# City of Tigard

## ADDENDUM #1

### OR99W: GAARDE/MCDONALD WATERLINE CROSSING PROJECT #CIP 96036

**WATERLINE CROSSING PLAN** C-4

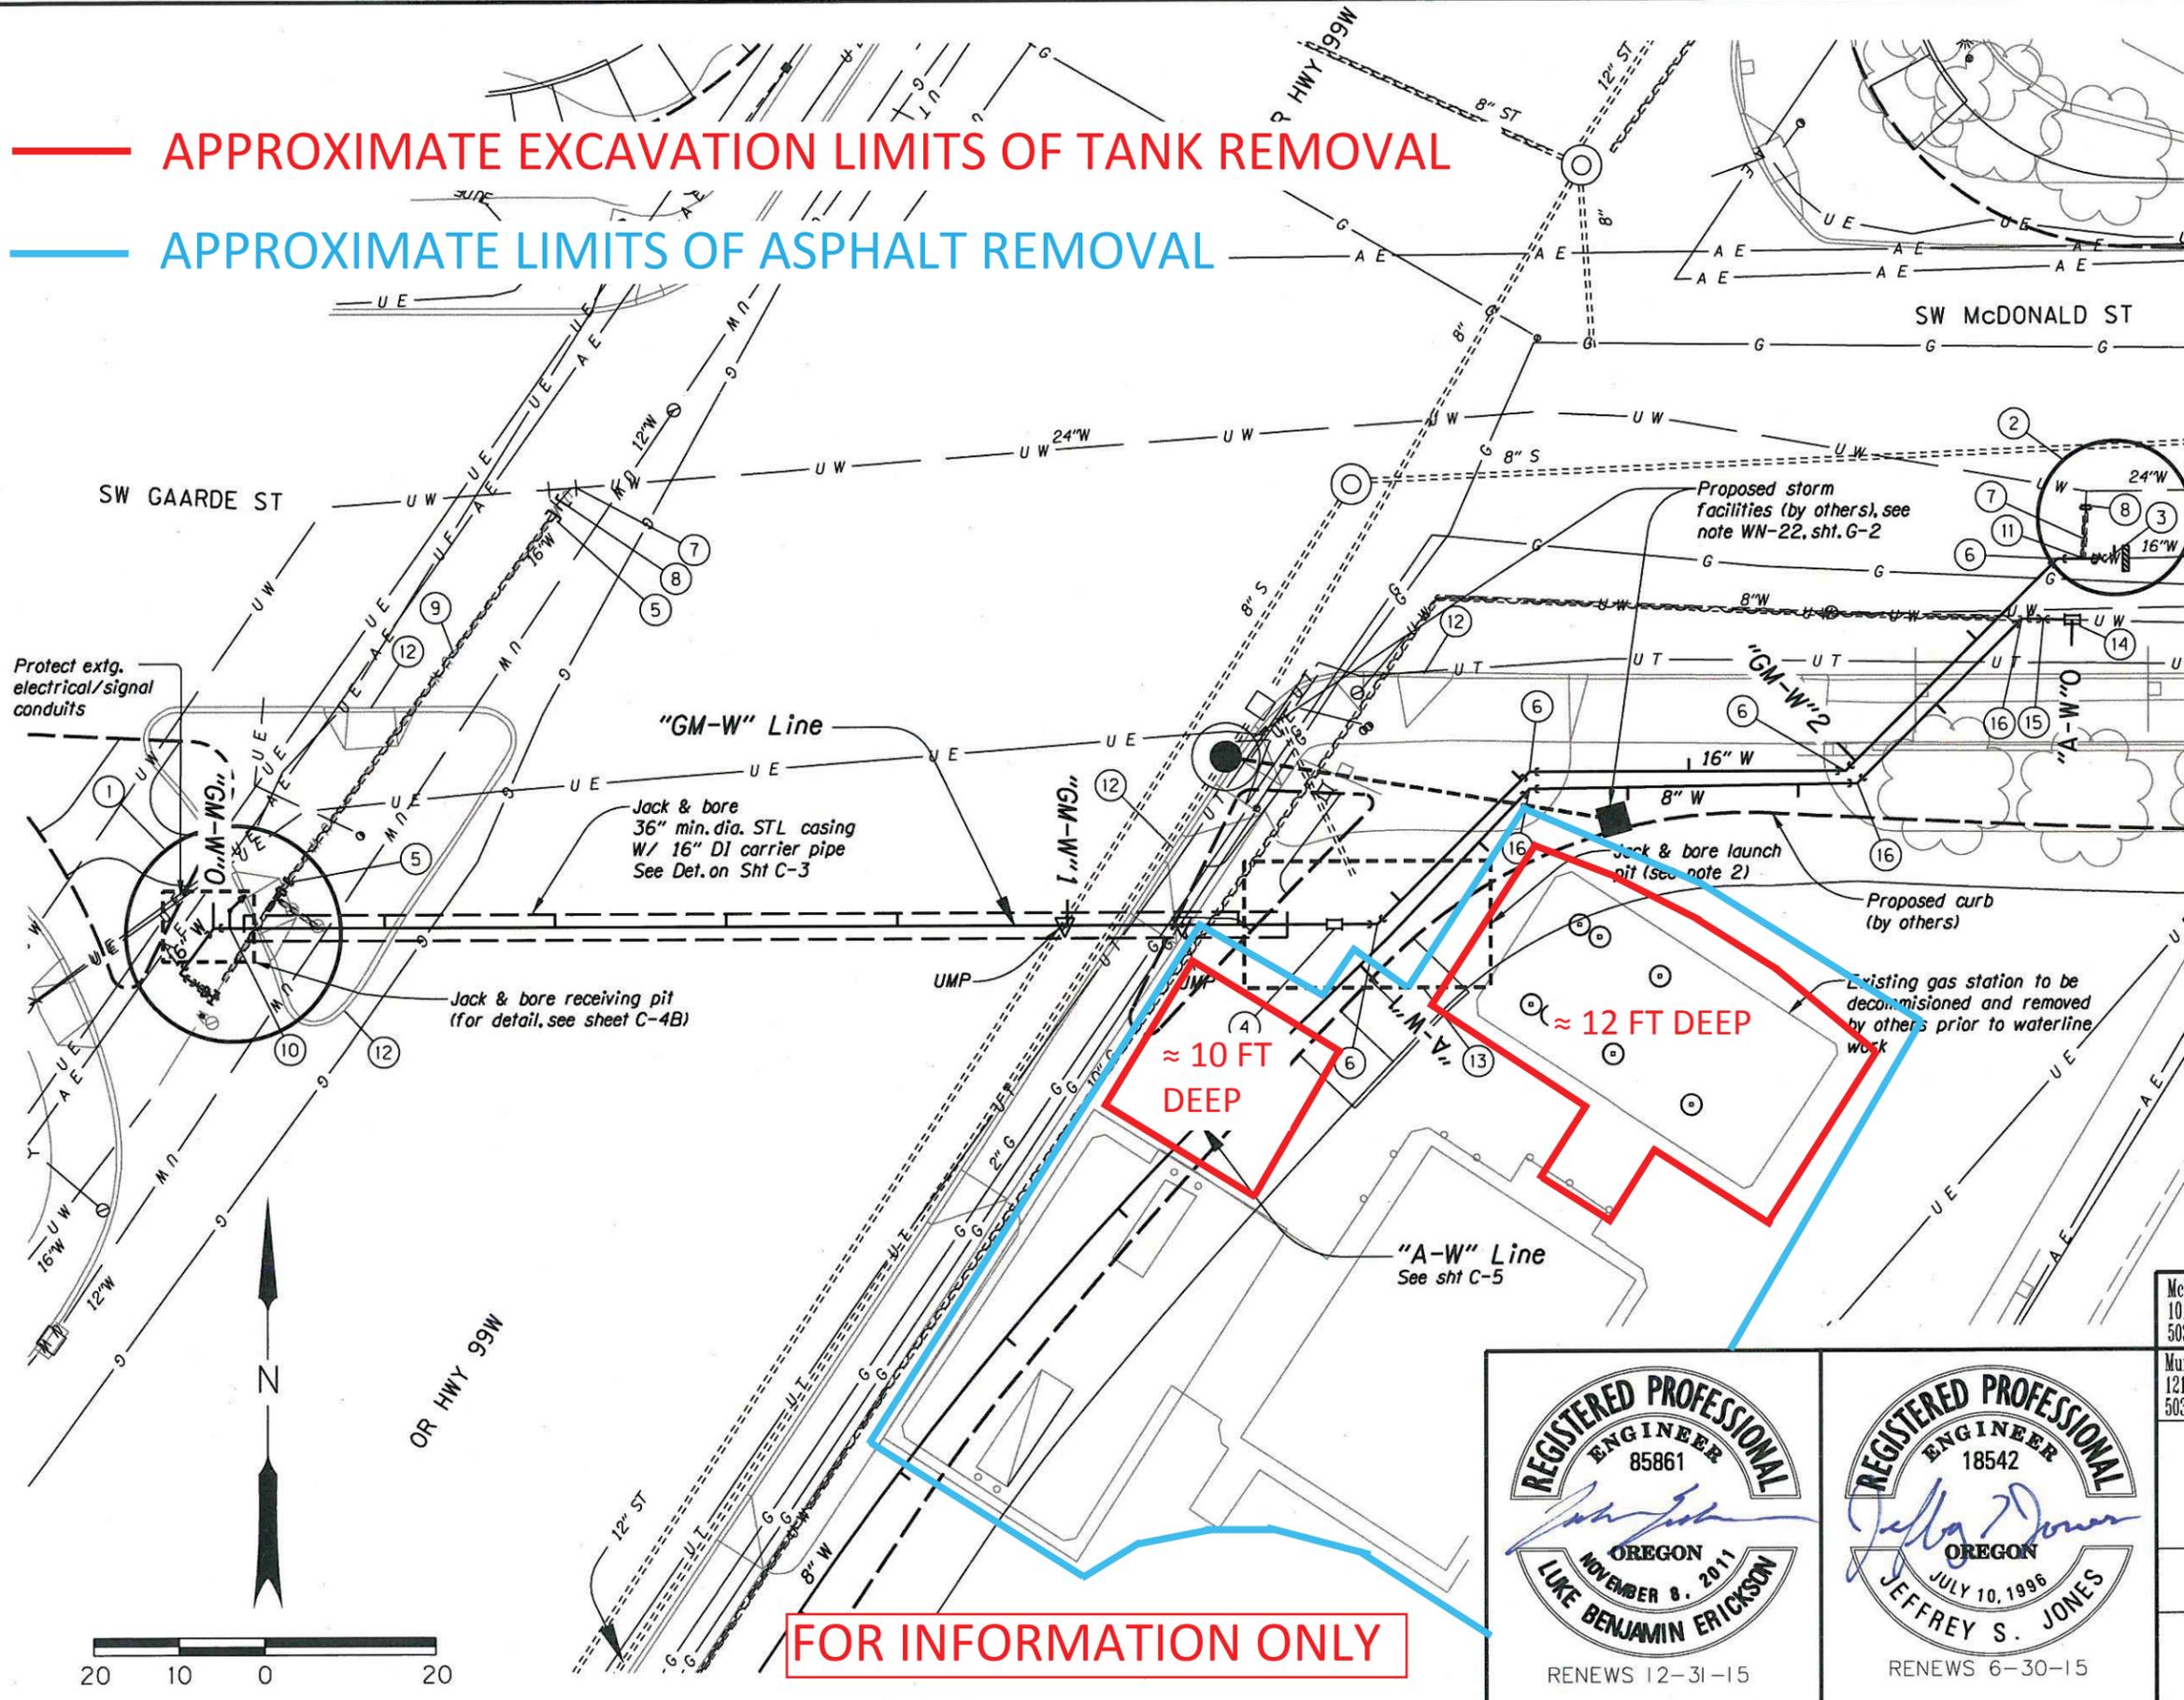
Existing underground storage tanks were removed in January 2015. These excavations were backfilled with clean material meeting the requirements of ¾” – 0 according to Section 02630 and constructed according to Section 00330.42.

The new backfill material excavated above the water table may be segregated and stockpiled onsite for reuse as backfill material in the pit excavations and where allowed in the trench section so long as the following conditions are met:

The new backfill material excavated **below** the water table may be segregated and stockpiled onsite for reuse as backfill material in the pit excavations and where allowed in the trench section.

The approximate extent of these excavations are provided on the attached sketch for information purposes below. No warranty on the accuracy of this information is provided by the City.

- Stockpiled material shall be protected as described in 00294.40.
- Segregated material must be tested to conform with DEQ clean fill standards including testing for total gasoline and diesel/oil range hydrocarbons with a single bulk sample.
- Sample results shall be provided to the City prior to reuse of the backfill.
- If tests results do not meet Oregon DEQ clean fill standards the backfill must be disposed of as described in Special Provision 00294

- Stockpiled material shall be protected as described in 00294.40.
- Stockpile material separately from backfill material excavated above the water table as groundwater is contaminated with petroleum hydrocarbons.
- Segregated material must be tested to conform with DEQ clean fill standards including testing for total gasoline and diesel/oil range hydrocarbons with a single bulk sample.
- This testing shall be conducted in addition to testing of fill above the water table.
- Sample results shall be provided to the City prior to reuse of the backfill.
- If tests results do not meet Oregon DEQ clean fill standards the backfill must be disposed of as described in Special Provision 00294
